SUNDRY NOTICES AND REPORTS ON WELLS

East Shugart Unit #29 Workplan

OPERATOR: K.P. Kauffman Company Inc.
WELL: East Shuagrt Unit #29
FIELD: Shugart
API # 30-015-05685
LEASE #: _____
UIC #: _____

Action 328400

PROPOSED WELLBORE DIAGRAM

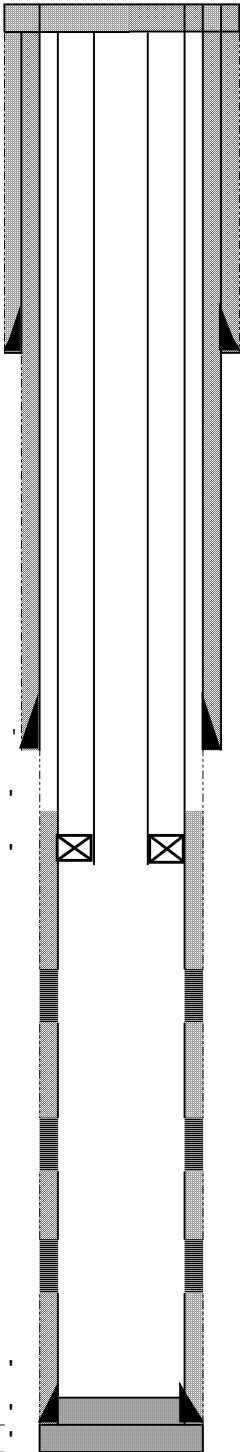
Created By	Condition	Condition Date
mgebremichael	Should the workover require a tube change, the same tube size shall be replaced as stipulated by the respective order. The packer shall not be set more than 100 ft above the perforation's top or the injection interval's top part. The work plan shall include installing BOP during the workover.	4/25/2024
